Tollway Standard Drawing Revisions

Section H	Roadway Lighting		
	Standard	Modification Summary	Effective: 07/07/15
	All	Revised detail descriptions to match Tollway Coded Pay Items	
		Updated drawings to follow IDOT highway standard levels	
		Re-arranged details between drawings for consistency	
	H1	Light Standard Foundation Details

BASE ATTACHMENT DETAIL

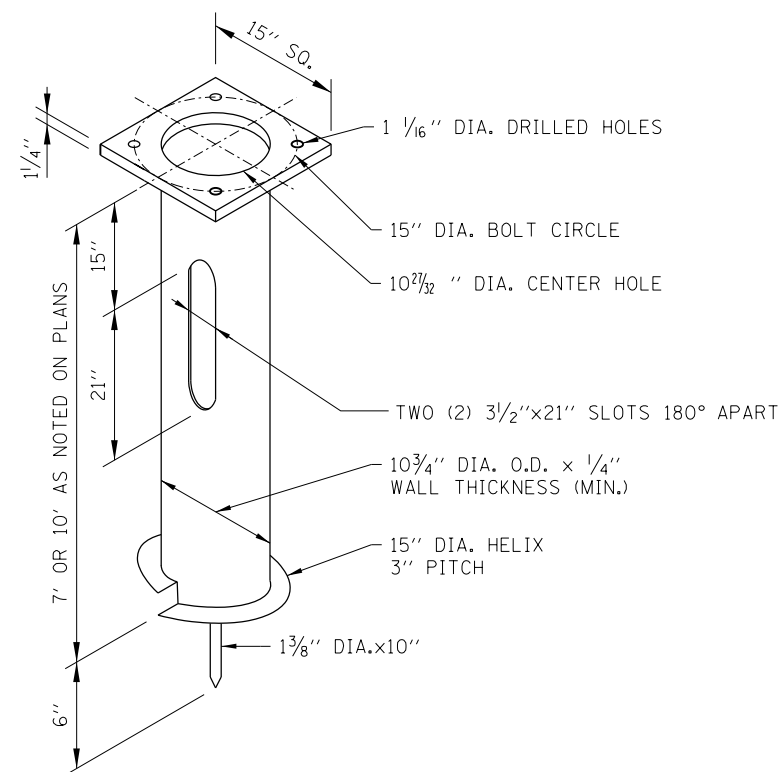
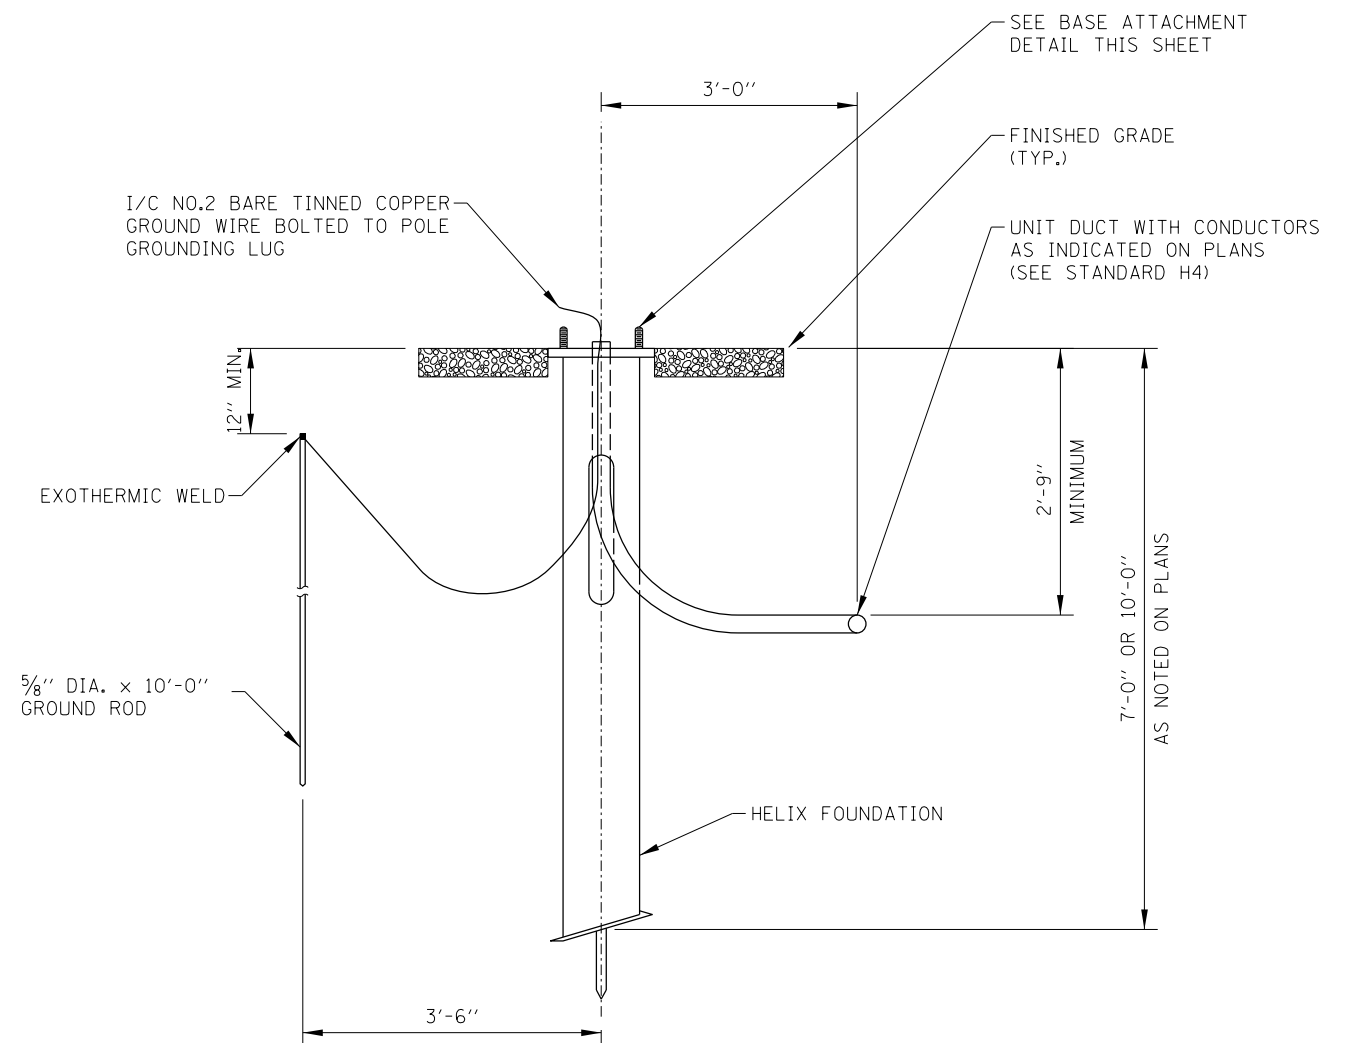
Sheet 1	Changed the ground rod detail for concrete foundations showing the rod extending through the concrete foundation	
		Revised notes	
	Sheets 3-6	Moved median barrier mounted foundation details from H8 to H1	
		Added pay limits to light standard foundation and median barrier wall	
	Sheets 7-9	Simplified grading details; Combined from sheets 1-5	
		Added earthwork and seeding details for transitions into graded area	
		Moved bridge mounted light pole mounting details to H2	
	H2	Light Standard Details

LIGHT STANDARD MOUNTING DETAIL
(GROUND MOUNTED UNITS)

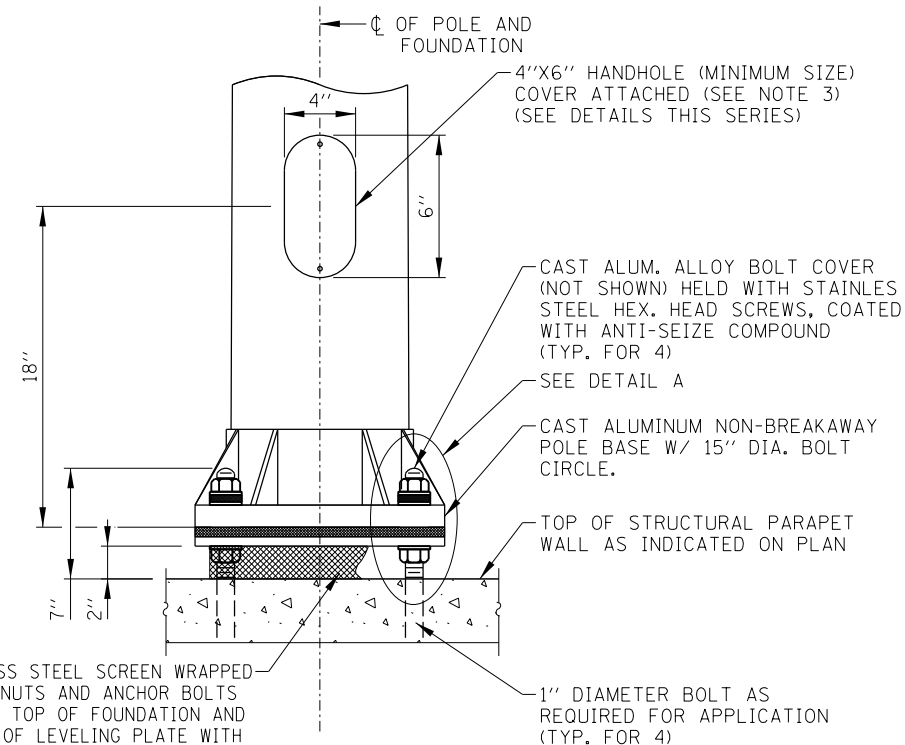
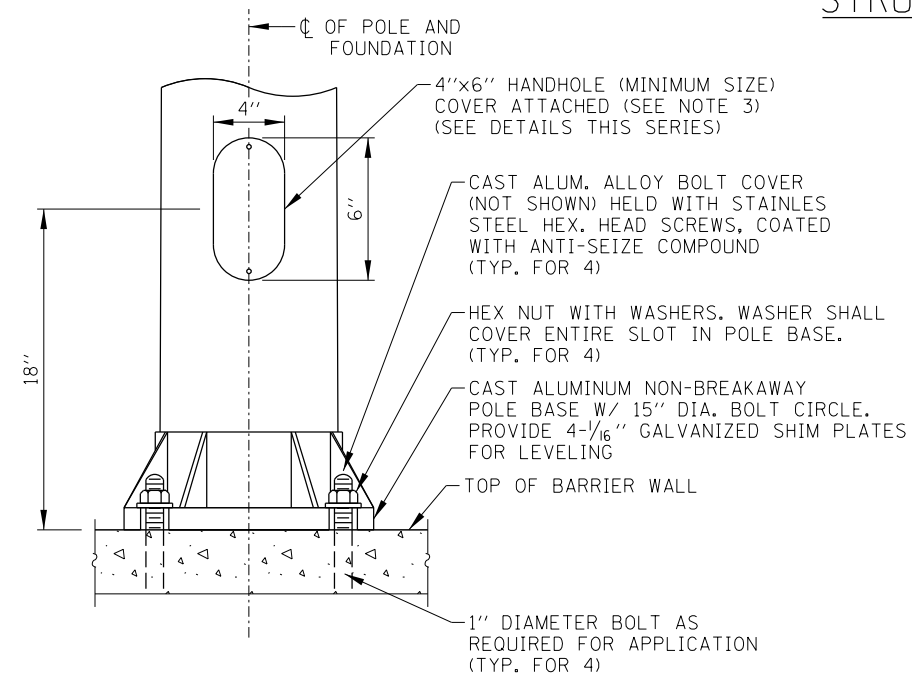
Sheet 2	Moved bridge mounted light pole mounting details from H1	
		Added detail showing light pole mounting to FHWA breakaway base for ground mount units	
		Added light standard description for LED luminaires	
		Provided complete light standard handhole orientation details

LIGHT STANDARD WIRING DETAIL
(GROUND MOUNTED UNITS)
(SEE NOTES 7 & 8)

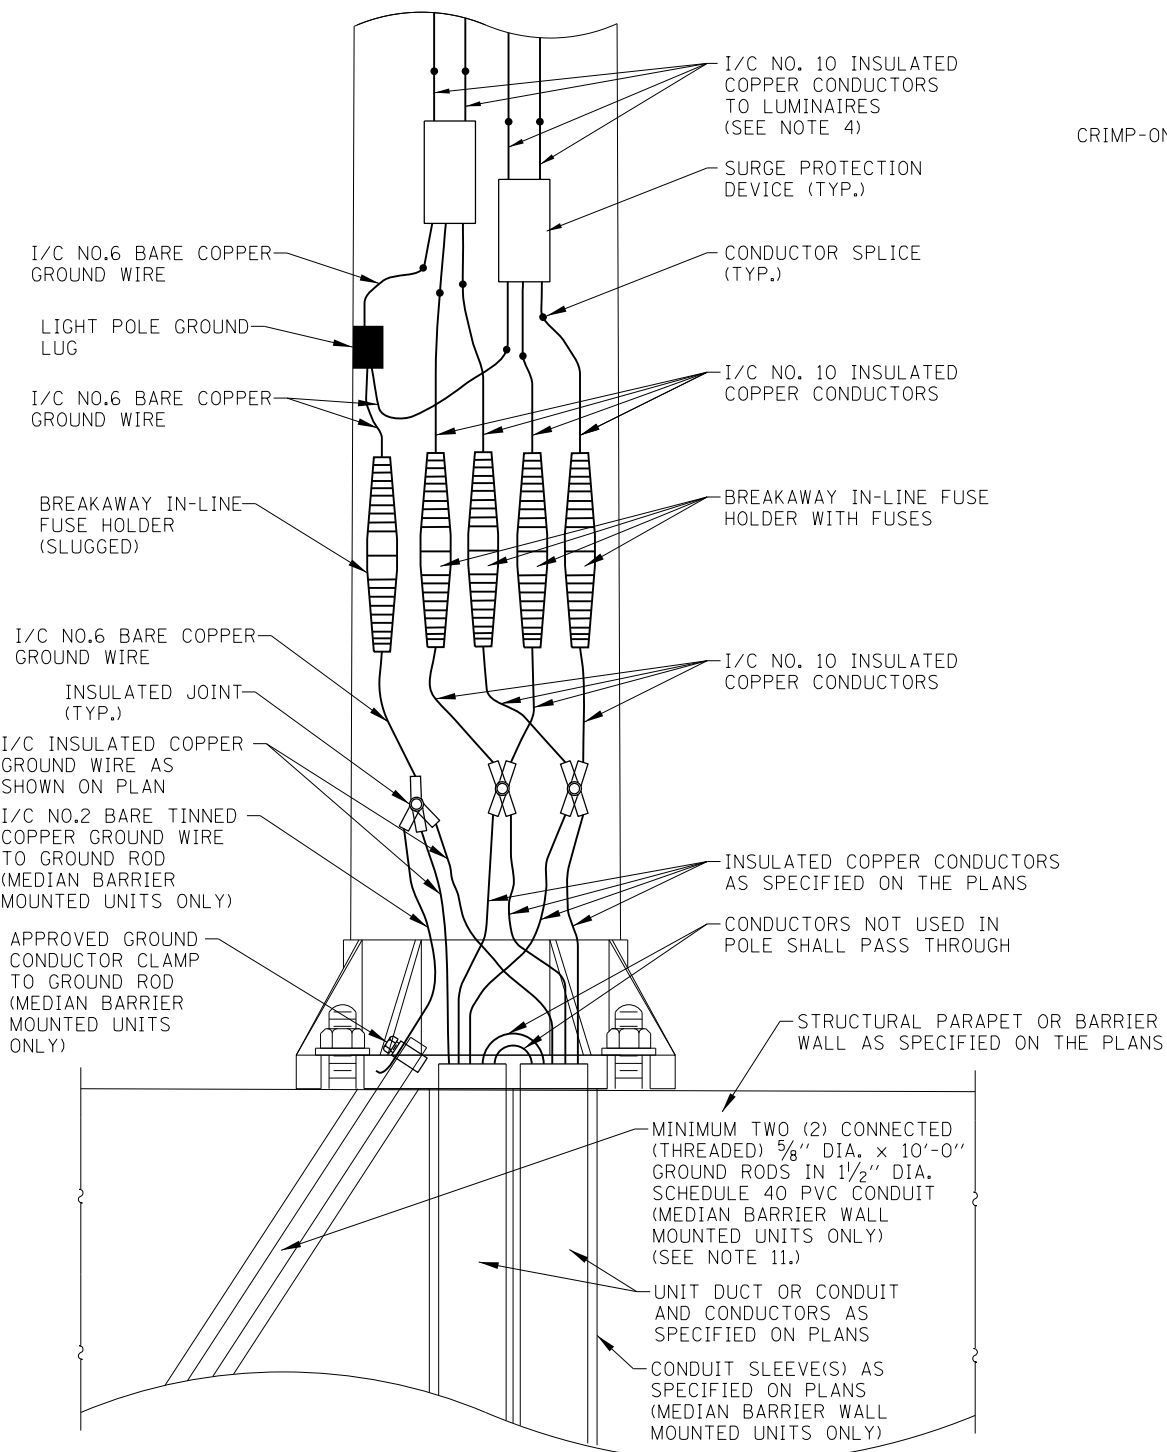
Sheet 3	Added surge protection devices to the light standard pole wiring details	
		Revised light standard pole wiring details to show difference between ground mounted and structure mounted units	
	H3	Bridge Conduit Details	
	All Sheets	Revised title.

CONDUIT EMBEDDED IN BRIDGE PARAPET

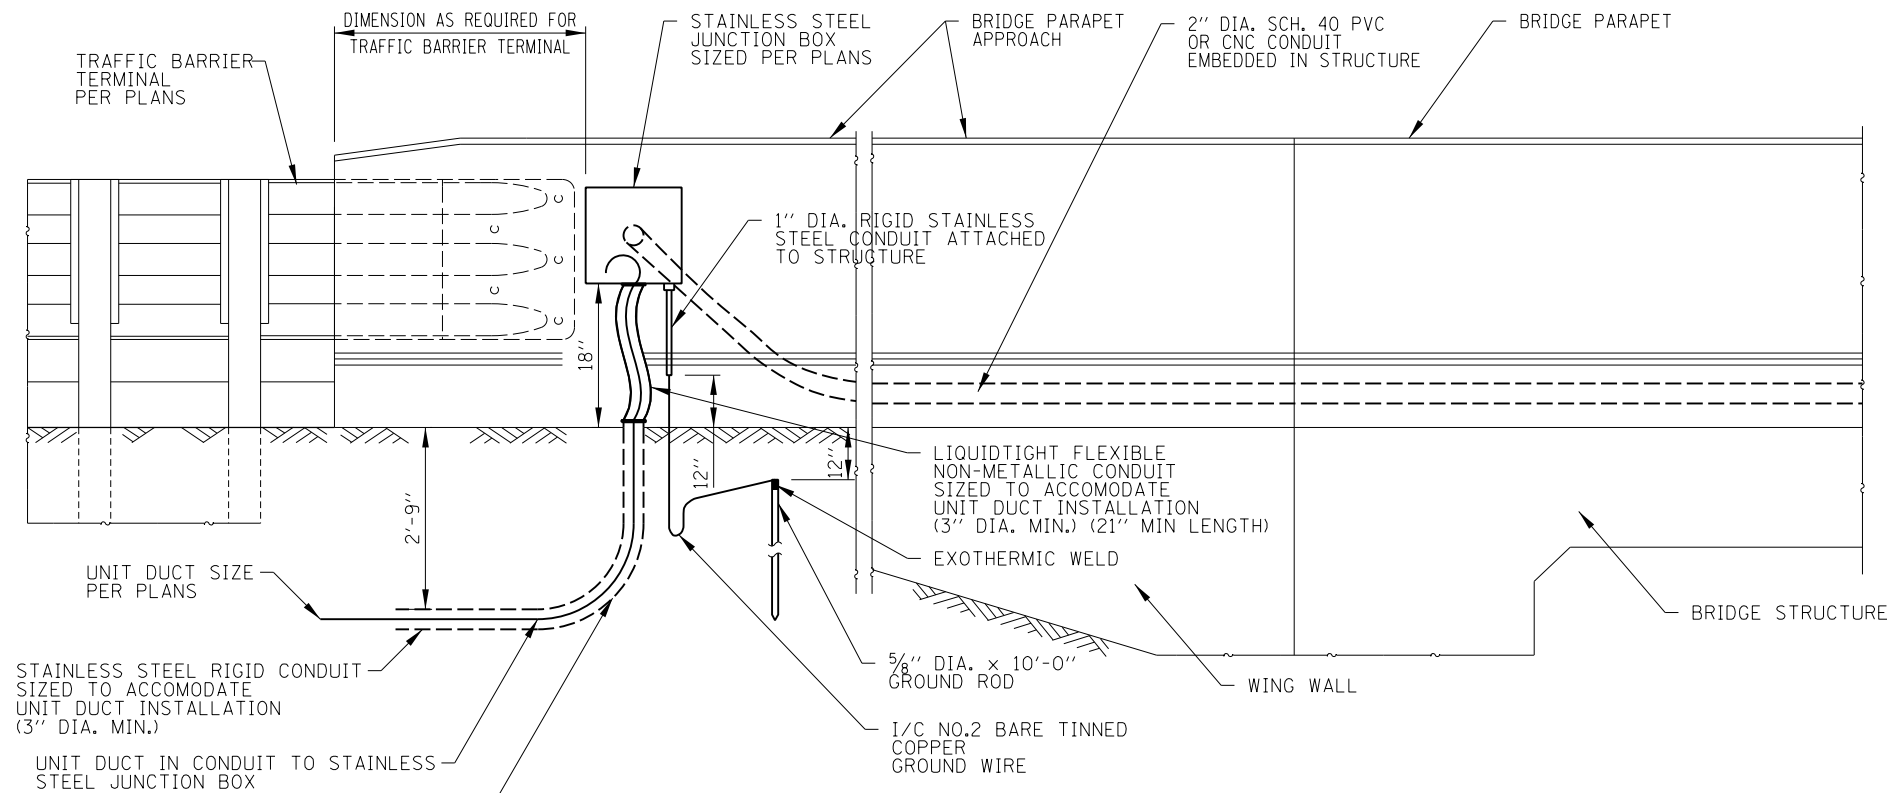
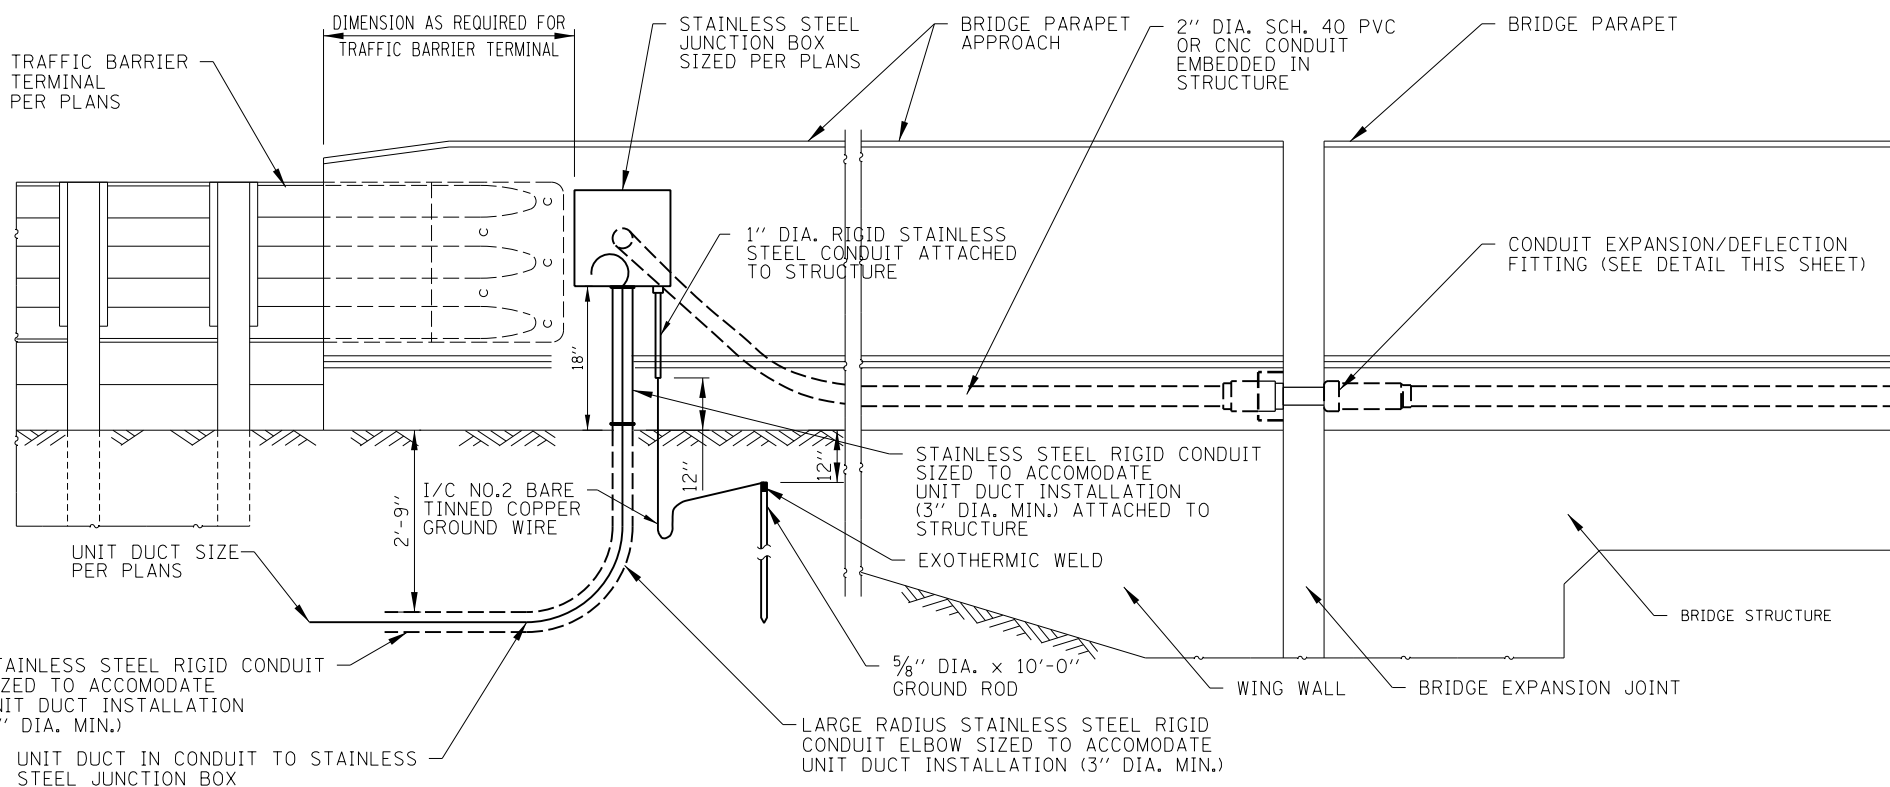
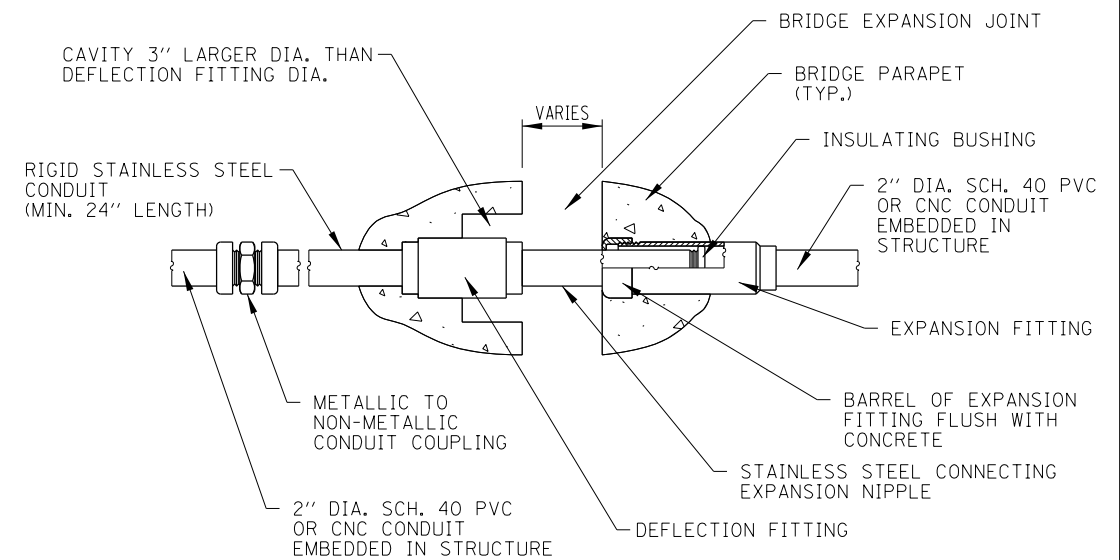
Sheet 1	Revised notes.	
	Sheets 2-4	Added details for transition from underground to conduit embedded in bridge structures with junction box mounted to back of bridge parapet (Test Level 5) similar to IDOT details. Tollway will no longer permit embedded junction boxes in bridge parapets due to Test Level 5 requirement.	
		Moved conduit embedded in bridge structures at light pole locations from H1.	
	H4	Heavy Duty Handhole and Buried Wiring Details	
		Deleted detail for trenching through pavement for conduit installation	
		Deleted non heavy-duty handhole details and notes	
		Deleted underground wiring modifications at existing light poles details.	
		Updated manufacturer's product information.	
		Revised notes.	
	H5	Service Pole and Pedestal Details	
		Revised underground metallic conduits to be stainless steel.	
		Revised above grade metallic conduits for transition to underground to be stainless steel.
